NOAA FORM 76-35A U.S. DEPARTMENT OF COMMERCE NATIONAL OCEANIC AND ATMOSPHERIC ADMINISTRATION NATIONAL OCEAN SERVICE DESCRIPTIVE REPORT			
1750	Type of Survey Field No. Registry No.	Hydrographic Survey N/A H11750		
-		LOCALITY		
Ì	State	Washington		
	General Locality	Approaches to Puget Sound		
	General Locality Sublocality	Approaches to Puget Sound Green Point to Dungeness Bay		
		Green Point to Dungeness Bay

Descriptive Report to Accompany Hydrographic Survey H11750

Project OPR-N372-RA-07 Approaches to Puget Sound, Washington Green Point to Dungeness Bay Scale 1:10,000 October – November 2007 **NOAA Ship RAINIER (s221)** Chief of Party: Commander Donald W. Haines, NOAA

Figure 2. Vertical Offset Error (vertical exaggeration is 108) Yellow line is 1021 DN 312, Pink line is 1016 DN 310, Orange line is 1016 DN 311

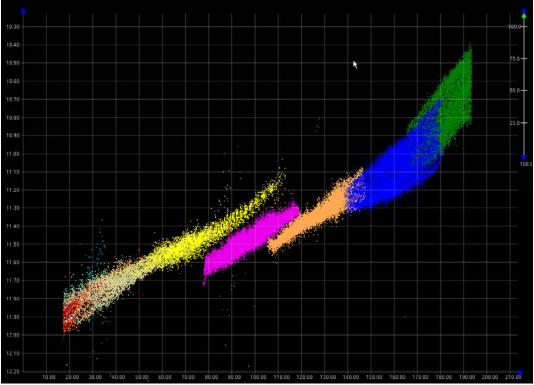
Offsets appeared in data collected on different days. Most offsets appeared in the eastern portion of the sheet in water shallower than 10 fathoms. The offsets averaged 0.15 meters with a maximum observed value of 0.3 meters, and varied day to day, leading to a preliminary conclusion that it is tide related. If so, the maximum value of 0.3 meters is within the allowable tide error budget of 0.45 meters as outlined in the NOS Hydrographic Surveys Specifications and Deliverables (April 2007)⁵.

⁵ Concur

Figure 3. VBES Heave Error in Launch 1101 data (vertical exaggeration is 64)

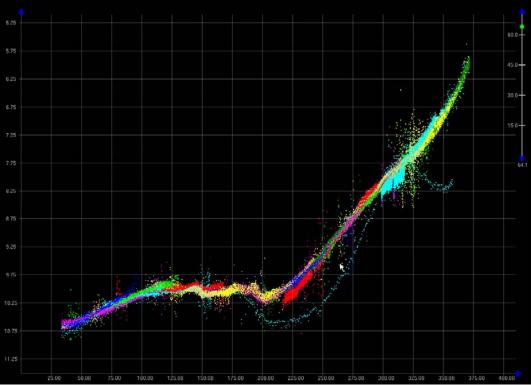
VBES data from Launch 1101 is consistently different when compared to MBES data in the same areas (waters shoaler than 10 meters). At the time of the survey, Launch 1101 used the DMS-05 heave sensor, and was unable to compensate for rapid acceleration through turns. This error was only noted on the shoreward start/end of these lines when it was necessary to quickly turn 1101 to get out of the shallows⁶.

⁶The heave errors fall within Specifications.

Figure 5. VBES coverage over 2 ³/₄ fathoms shoal (Chart 18465)

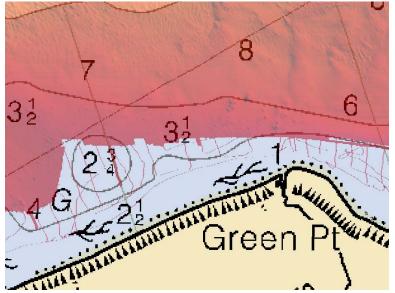
Due to time constraints, RAINIER did not obtain coverage over the 2 ³/₄ fathoms shoal, 1,250 meters west of Green Point. Inside the 8 meter curve, RAINIER only obtained VBES data with 100 meter line spacing.

As mentioned in § B2, Data Quality Factors, RAINIER did not obtain complete MBES coverage over the charted 2 ³/₄ fathoms shoal 1,250 m west of Green Point (Figure 5). The Hydrographer recommends retaining this shoal as charted⁹.

⁹ Concur

Figure 10. 15.8 fathom sounding over charted 17 fathom sounding (Chart 18465)

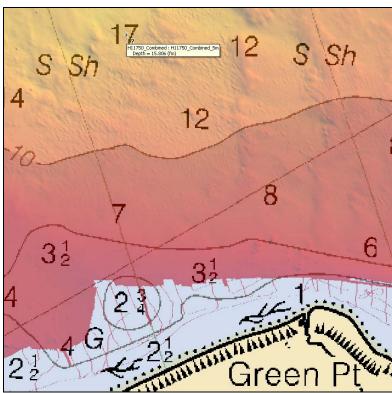
Bathymetry generally agreed with charted depths within 1 fathom with the exceptions of water deeper than 50 fathoms and a shoaler sounding shown in Figure 10. In water deeper than 50 fathoms (in the northeast corner of the survey), the charted depths agreed within 2 fathoms. Contours show a general deepening outside the 3 fathom curve⁸.

⁸ Concur

Figure 11. Charted 2 1/2 fathoms shoal east of Green Point

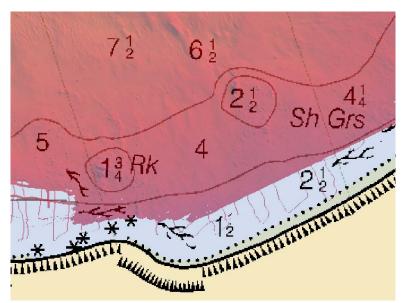
RAINIER obtained complete MBES over the 2 $\frac{1}{2}$ fathoms shoal 3,400 meters east of Green Point (Figure 11). The Hydrographer recommends updating the position of the shoal¹⁰.

¹⁰ Concur. Chart as depicted in the HCell.

Figure 12. Charted rocks and wrecks on Charts 18465 (left) and 18440 (right)

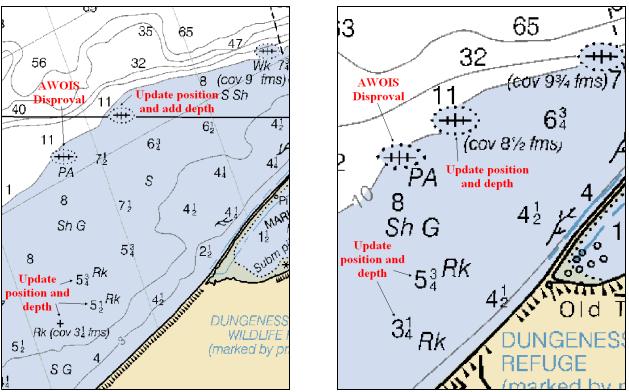
The charted PA wreck (Figure 12) assigned for AWOIS investigation (see § D.1.c) was disproved with complete MBES and SSS. The Hydrographer recommends removing it from the chart¹¹. There is also a dangerous wreck charted just to the northeast of the PA wreck. This dangerous wreck was seen in both the bathymetry and the imagery, although the remains are widely distributed with minimal relief. The Hydrographer recommends retaining the charted wreck and updating the position and sounding information as per the digital data¹².

Three rocks are charted in the southeast corner of the survey (Figure 12, left, Chart 18465). The southwestern rock, with a depth of 3 $\frac{1}{4}$ fathoms, is the significant feature. The northern and eastern rocks, with depths 5 $\frac{3}{4}$ and 5 $\frac{1}{2}$ fathoms respectively, are relatively minor, as compared to the surrounding depths and nearby features. The Hydrographer recommends changing the charted southwestern (3 $\frac{1}{4}$ fms) rock and legend to match that on chart 18440, retaining the northern (5 $\frac{3}{4}$ fms) and eastern (5 $\frac{1}{2}$ fms) rocks as charted, and updating the position and sounding information on all three rocks¹³.

As on Chart 18465, the charted PA wreck (Figure 12) assigned for AWOIS investigation (see § D.1.c) was disproved with complete MBES and SSS. The Hydrographer recommends removing it from the chart. As above, the charted dangerous wreck northeast of the PA wreck was seen in both the bathymetry and the imagery, although the remains are widely distributed with minimal relief. The Hydrographer recommends retaining the charted wreck and updating the position and sounding information as per the digital data¹⁶.

Of the three rocks that appear on Chart 18465 (Figure 12), only the southwestern (3 ¹/₄ fms) and northern (5 ³/₄ fms) rocks are charted on 18440. The Hydrographer recommends retaining the rocks as charted and updating the position and sounding information as per the digital data¹⁷.

- ¹¹ Concur. The wreck, AWOIS #52054, has been removed from the HCell.
- ¹² Concur. Chart wreck as depicted in the HCell.
- ¹³ Concur. Chart three rocks as depicted in the HCell
- ¹⁴ Concur
- ¹⁵ Concur
- ¹⁶ Concur
- ¹⁷ Concur. Chart rocks as appropriate for chart scale.
- ¹⁸ Concur
- ¹⁹ Concur
- ²⁰ Concur
- ²¹ Concur
- ²² See endnote #11
- ²³ Concur
- ²⁴ Concur

Figure 13. VBES coverage over 2 ³/₄ fathoms sounding (Chart 18440)

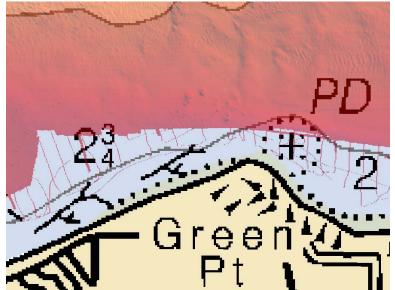
As mentioned in § B2, Data Quality Factors, RAINIER did not obtain complete MBES coverage over the charted 2 ³/₄ fathoms sounding 1,250 m west of Green Point (Figure 13). The Hydrographer recommends retaining this sounding as charted¹⁵.

Figure 14. Charted PD rock awash and PA rock (Chart 18440)

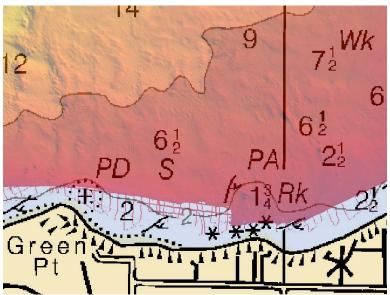
Just to the northeast of Green Point is a charted PD rock awash (Figure 14). Although outside the area of complete MBES coverage, this rock was not seen during shoreline verification, in the VBES star pattern, or in the partial SSS imagery. This feature is not charted on 18465. The Hydrographer recommends removing the charted rock awash¹⁸.

There is a charted PA rock with depth 1 ³/₄ fathoms 2,500 meters east of Green Point (Figure 14). This rock was seen in the bathymetry. The Hydrographer recommends updating the position of the rock and removing the legend "PA"¹⁹.
